Jefferson County School District Metolius Elementary School Upgrades

ADDENDUM NO. 01 June 01, 2023 - Revised June 30, 2023

CLARIFICATIONS: To the Construction Documents
PART 1: Revisions to the Project Manual
PART 2: Revisions to the Working Drawings
PART 3: Substitution Requests

1
A6.01
OVERALL RCP
SCALE: 1/16" = 1'-0"

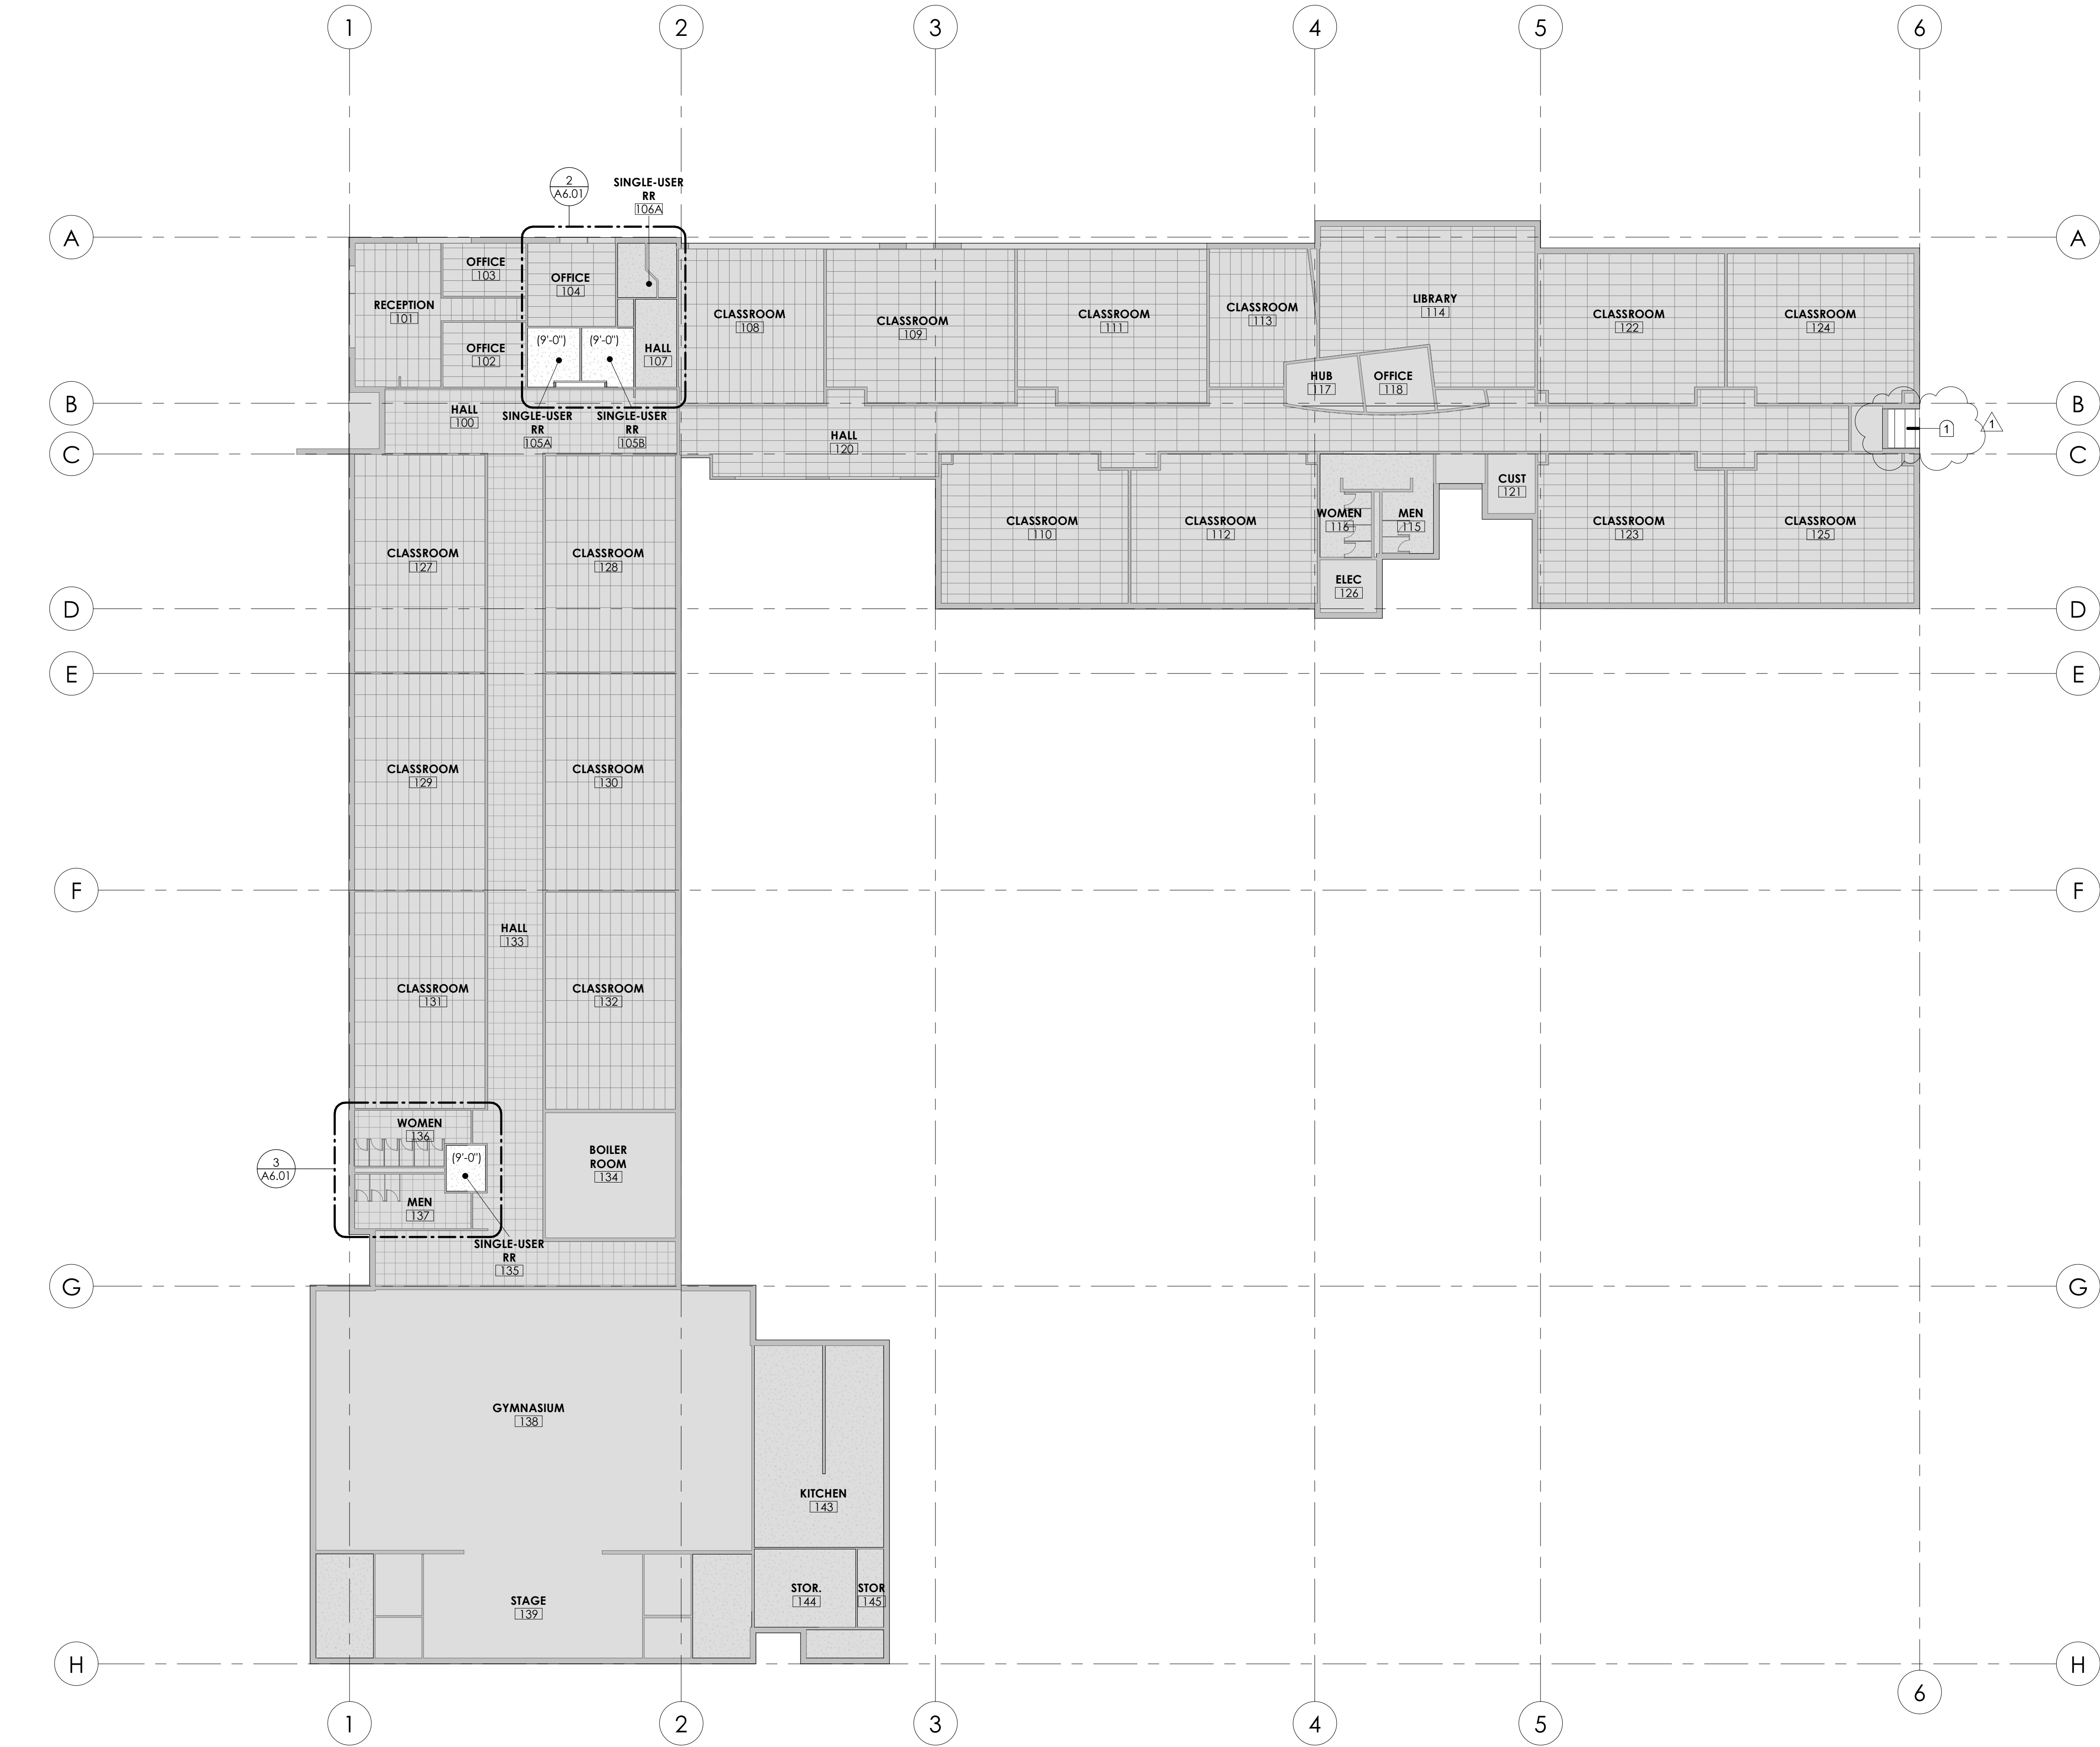
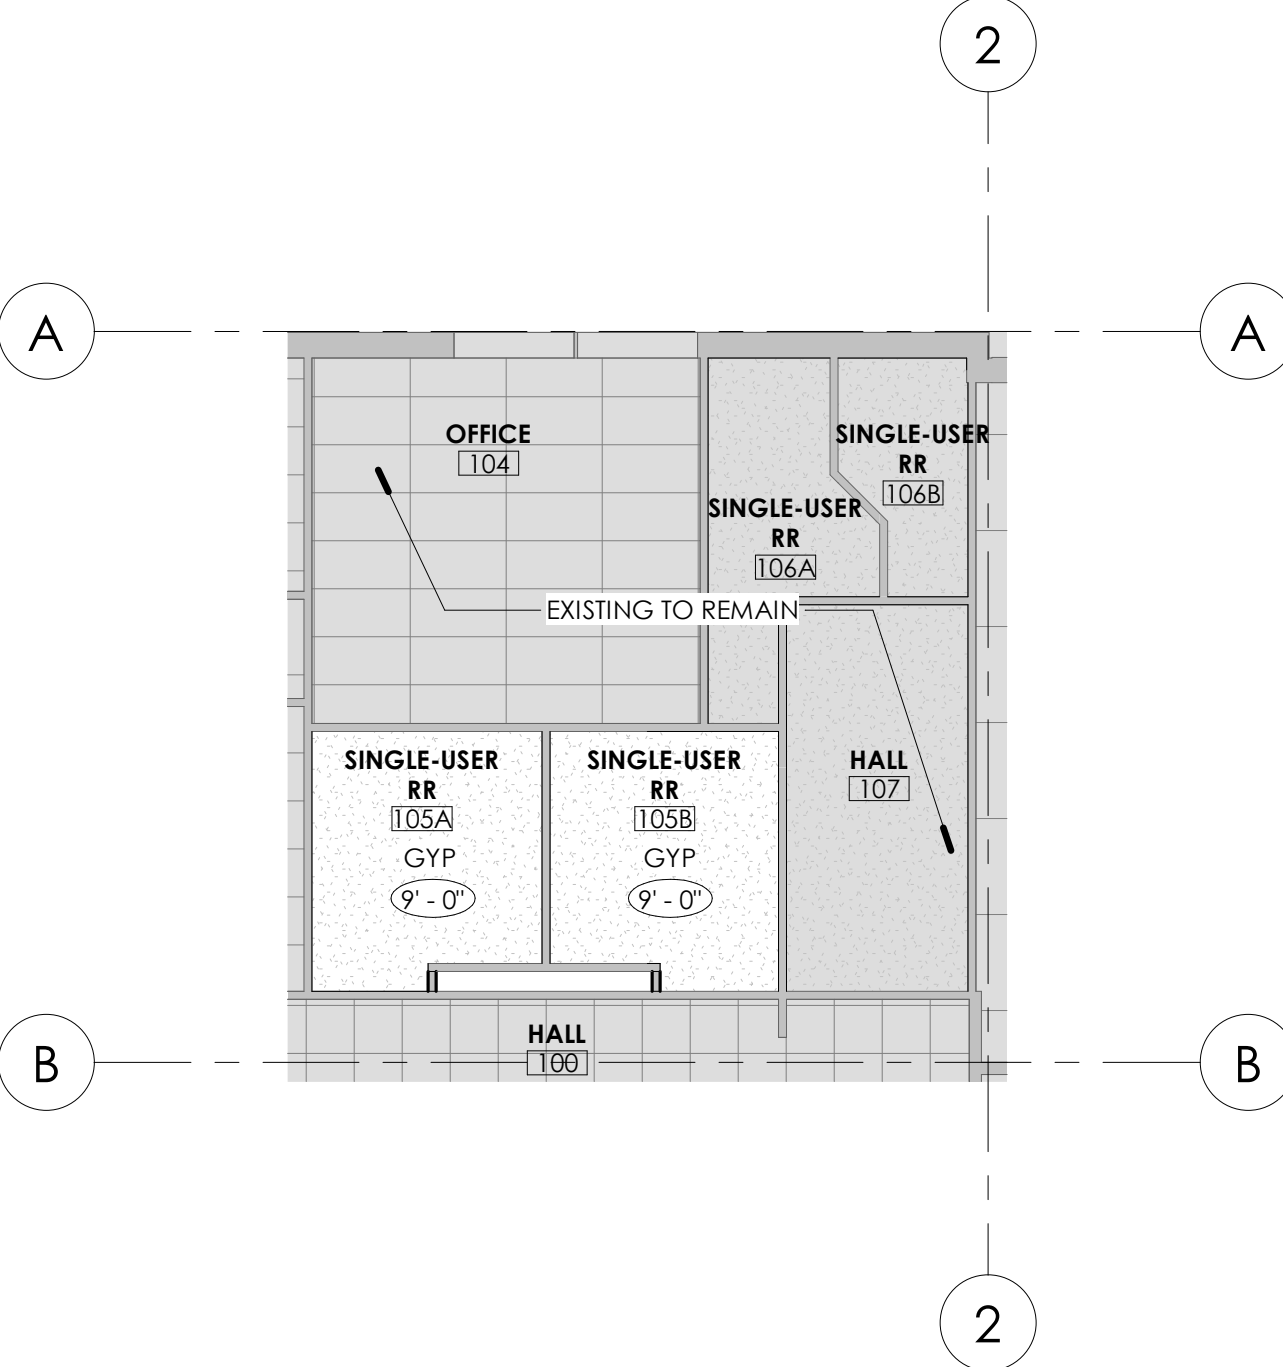
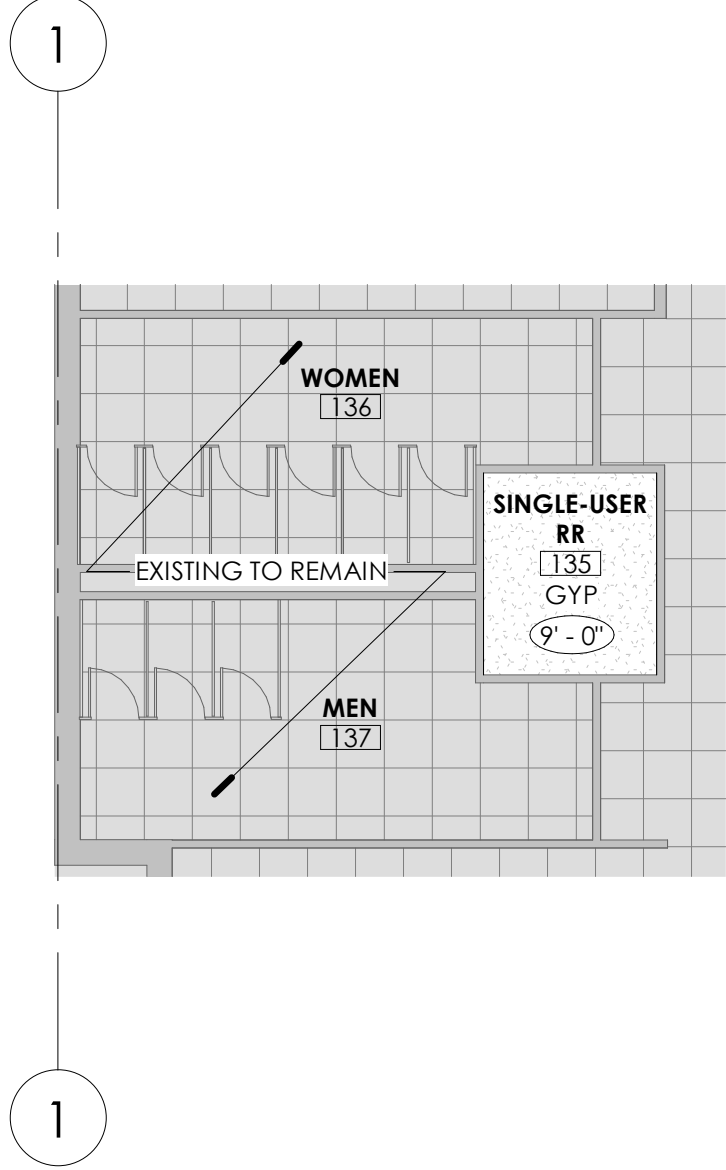
- 2.1 Modifications to Sheet G0.00 – Cover Sheet:
 - A) Modified project description: revised replacement of (6) cooling coils/condensers to (7).
 - B) Modified project description: added "New fire alarm system throughout"
- 2.2 Modifications to Sheet AD6.01 – Demolition Reflected Ceiling Plan:
 - A) Added Keynote 3
- 2.3 Modifications to Sheet A6.01 – Reflected Ceiling Plan:
 - A) Added Keynote 1

4 FLOOR - TRANSITIONS
SCALE: 3" = 1'-0"

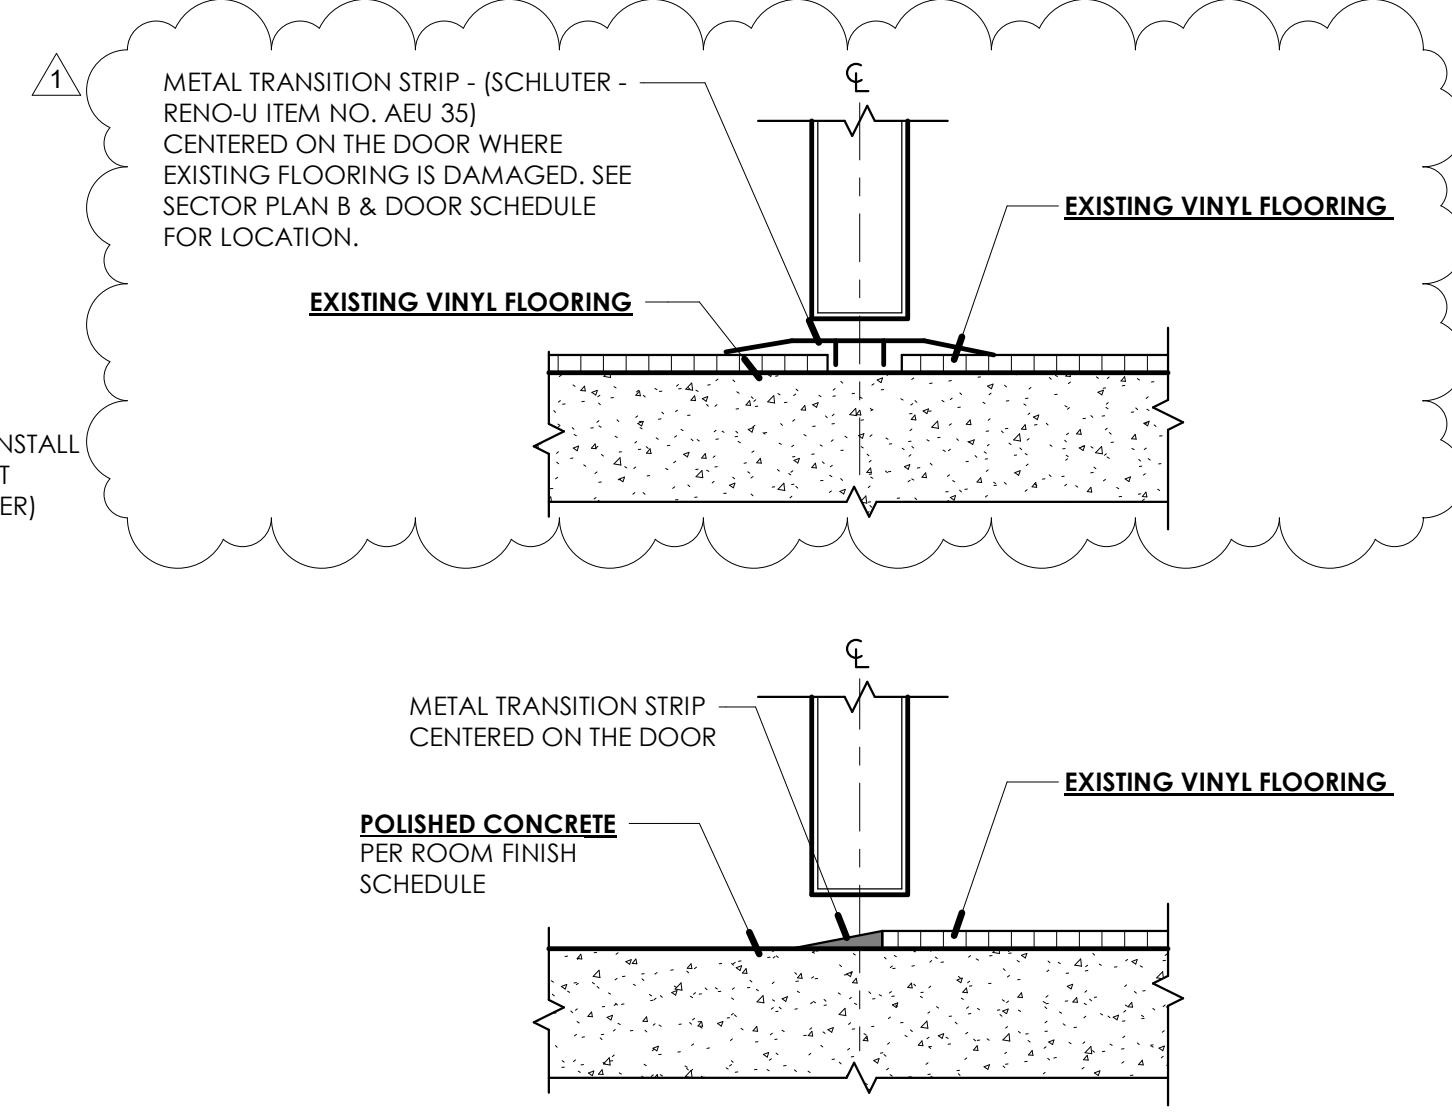
A) Detail 6 – Added product information for transition strip.
- 2.6 Modifications to Sheet M2.11 – Floor Plan – Level 1 – Sector B:
A) Added tags to ductwork
